From: John Lawson
Sent: 15/08/2023 12:34:45 PM
To: Council Northernbeaches Mailbox
Subject: DA2023/1023 - 32 Loblay Crescent Bilgola Plateau - Submission Opposing the Development Application
Attachments: Photo 10 bdry sstone steps rock face intersection.jpg; Photo 11 Rear Verbannum trees string - -wall boundary.jpg; Photo 12 - Existing garden lin #34 looking to #32.jpg; Photo 1 Front Lilli Piily - existing walls gfront v boundary.jpg; Photo 2 bdry line Verbannum trees locations.jpg; Photo 3 tree1 -wall intersection.jpg; Photo 4 Tree1 with flock of birds.jpg; Photo 5 west ffront exist walls v boundary stake & height walls.jpg; Photo 6 frnt retaining wall gas meter.jpg; Photo 7 our sandstone wall - fence locatioin.jpg; Photo 8 Bdry on top of SStone Wall.jpg; Photo 9 fence rock outcrop bdry interscetion.jpg; Tree Lopping Invoice INV-0725 (1).pdf; DA-02 Revised.pdf; D03 - Revised.pdf; DA-01 Revised.pdf; Sketch Section at Start SStone Steps.pdf; SUBMISSION IN REGARD TO DA20231023 - 32 Lobaly Cresc. Bilgola Plateau.pdf; Access to Neighbouring Land Agreement3 JL.pdf;

SUBMISSION IN REGARD TO DA/2023/1023 - 32 LOBLAY CRESCENT BILGOLA PLATEAU

Description: Alterations and additions to a dwe

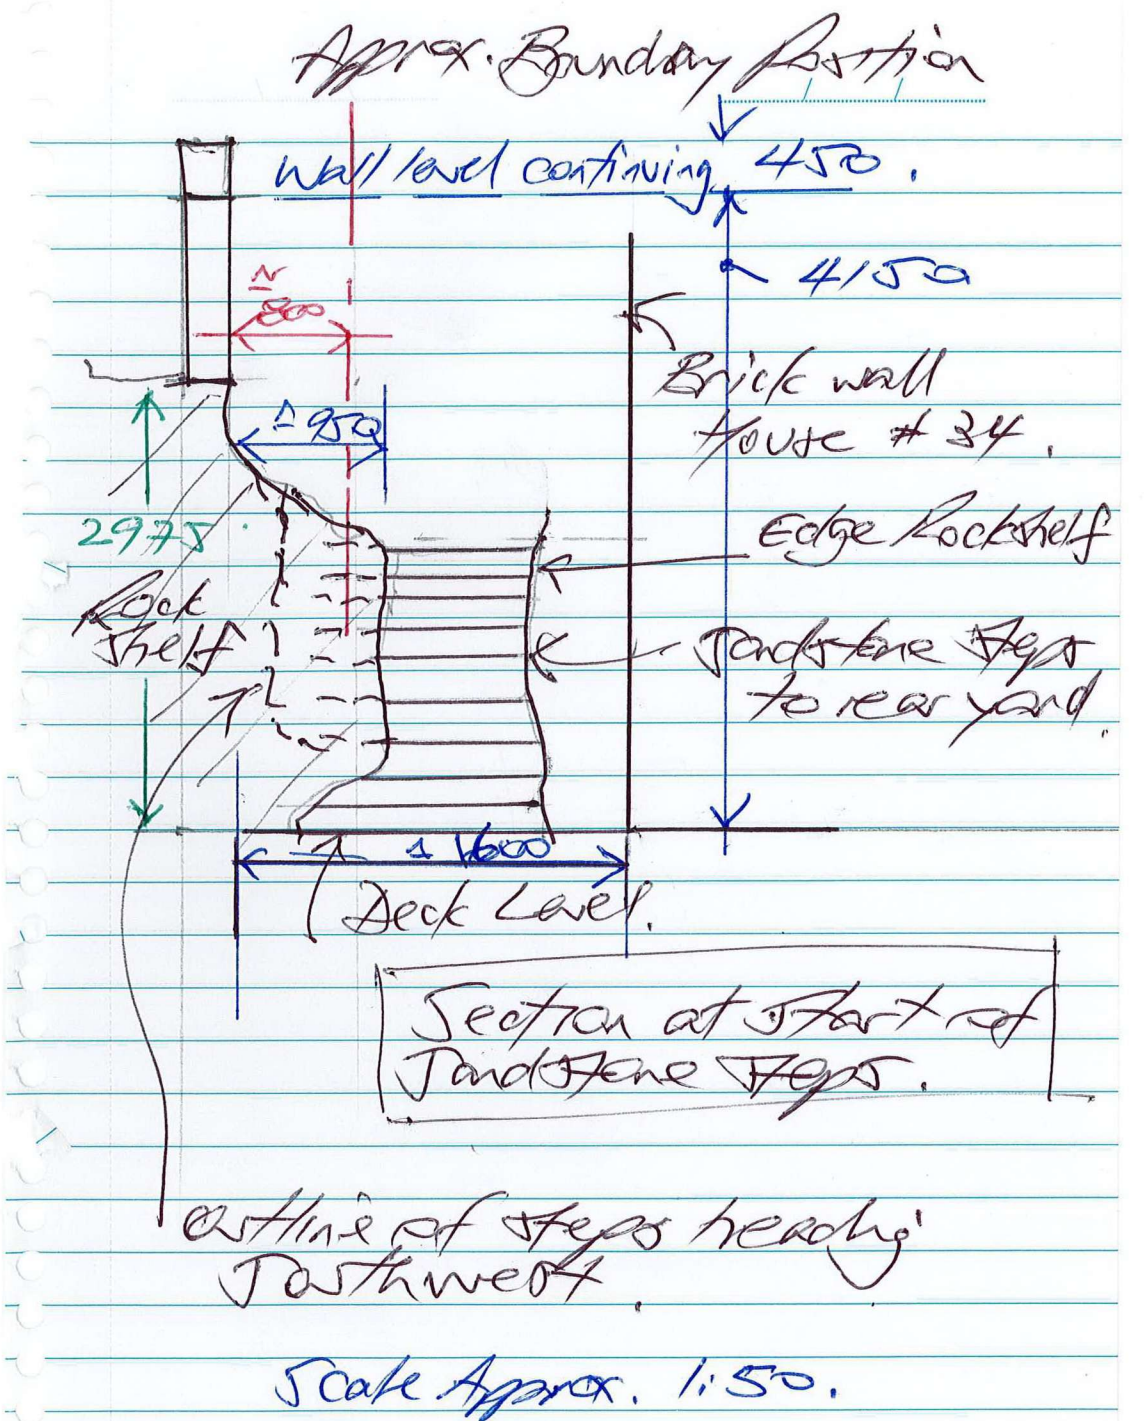
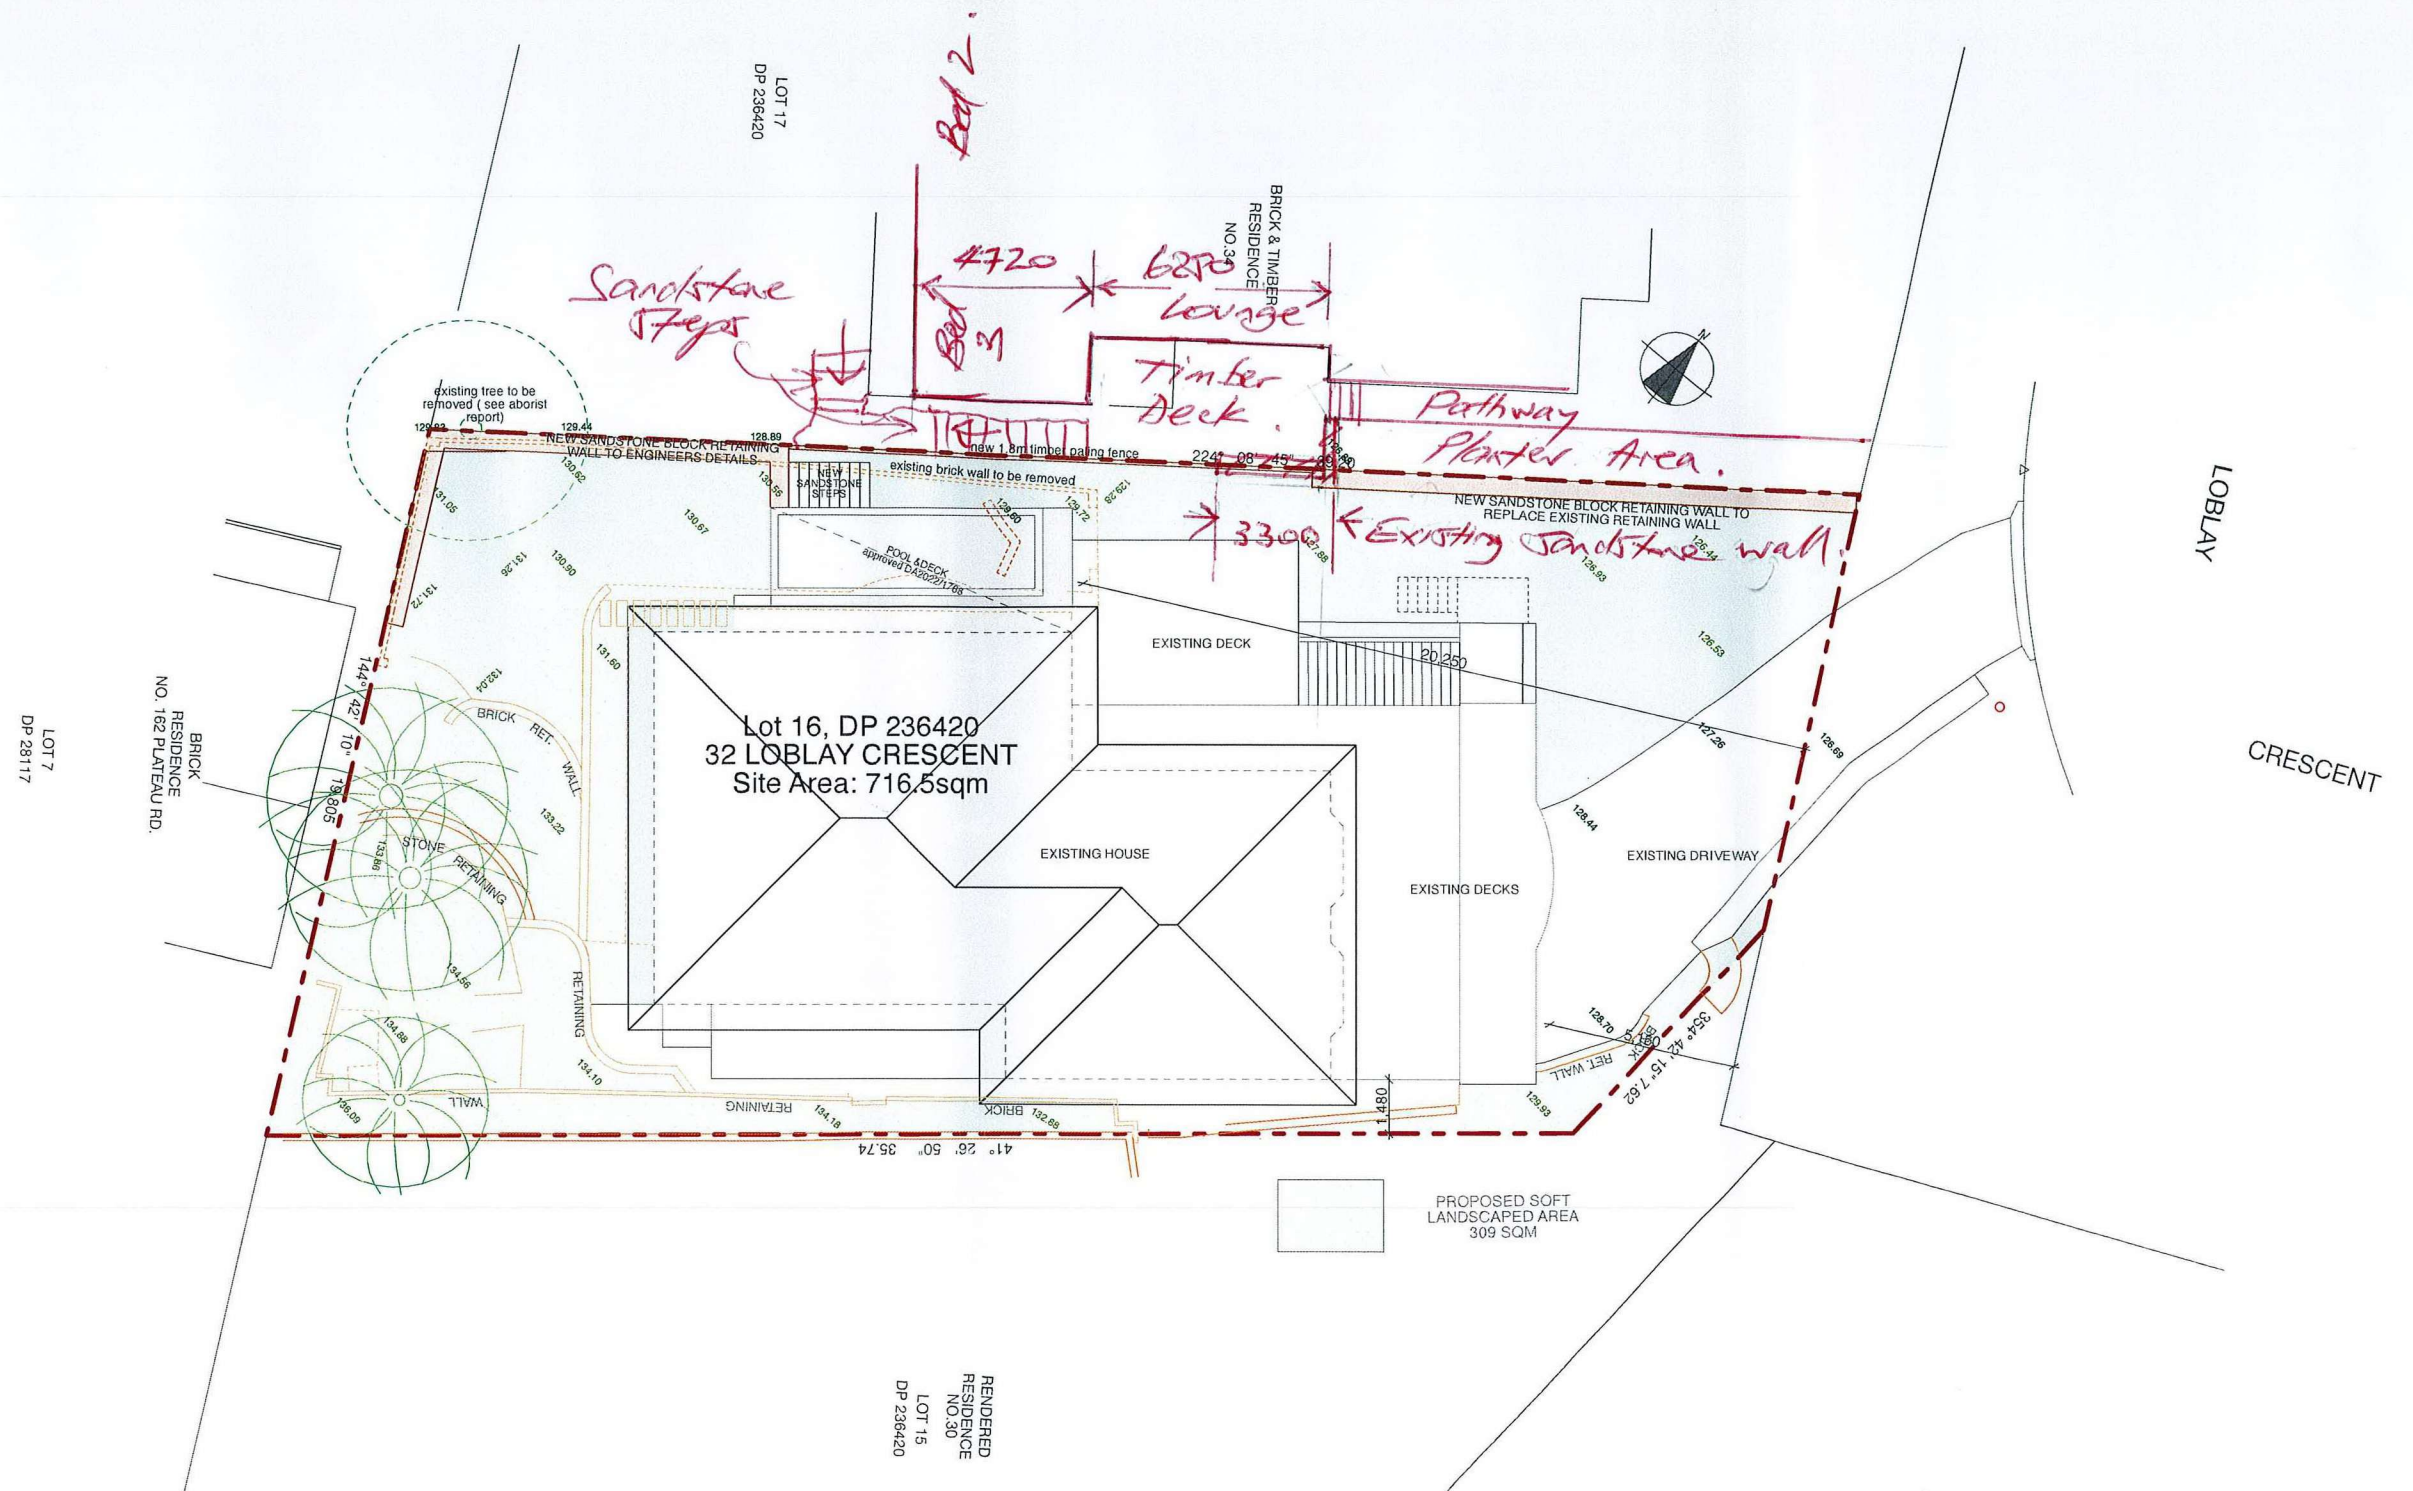
1. **Survey Details are incorrect – re the position of our house on the Plans provided.**

I have attached a revised Plan DA-01 showing the correct alignment.

Correct House dimensions #34 & installations.

Correct House dimensions #34 & installations.
